Environmental Impact Assessment (EIA), scoping phase, on lifetime extension Loviisa 1&2

Organisation: Wiener Plattform Atomkraftfrei, www.donauregion-atomkraftfrei.at

Date: 20.10.2020

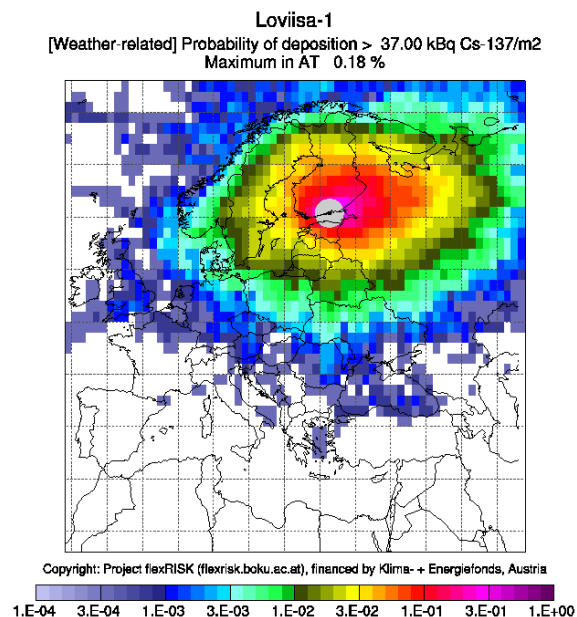
The research project flexRISK shows that a steam generator tube rupture accident in Loviisa unit 1 or 2 could release up to 30% of the radioactive inventory, that is 31.5 PetaBecquerel Cs-137.

The following flexRISK figure shows the weather-related risk for Europe to be contaminated with Cs-137 above 37 KiloBecquerel Cs-137 per m² in case of such an accident happening.

Under unfortunate weather conditions, almost every country in Europe could suffer such a high Caesium contamination.,

The EIA Report shall also include accident calculations with the highest source term for which the risk is not zero, and dispersion calculations for all of Europe.
